## COMMUNITY FEEDBACK SUBMISSION

### WESTCONNEX STAGE 1 – M4 EAST TUNNEL

**Figure 6 – Alternative entry ramp using Leicester Ave. This will require resumption of properties on the western side of Leicester Ave for an additional left lane descending into the entry ramp.**

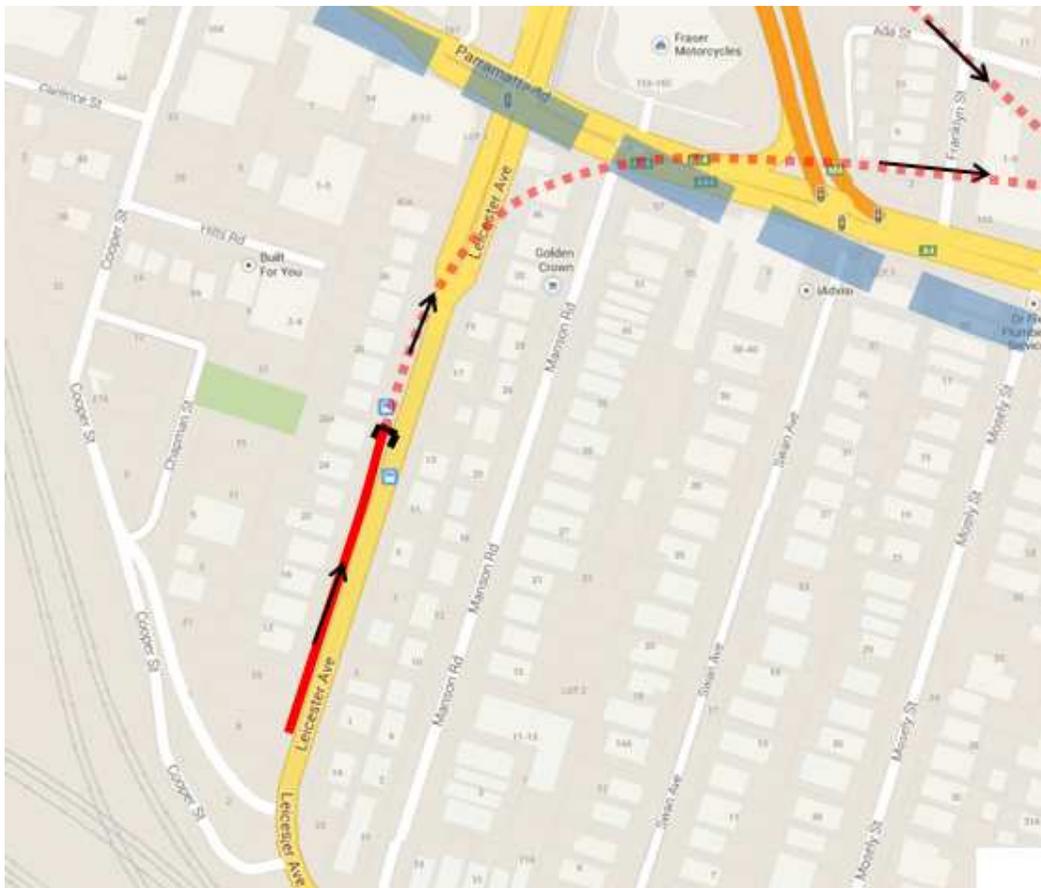
A second alternative is shown in Figure 6. This has similar advantages to the Cooper St option, but would also utilise the rising land gradient to allow a shorter surface road before entry into the portal.
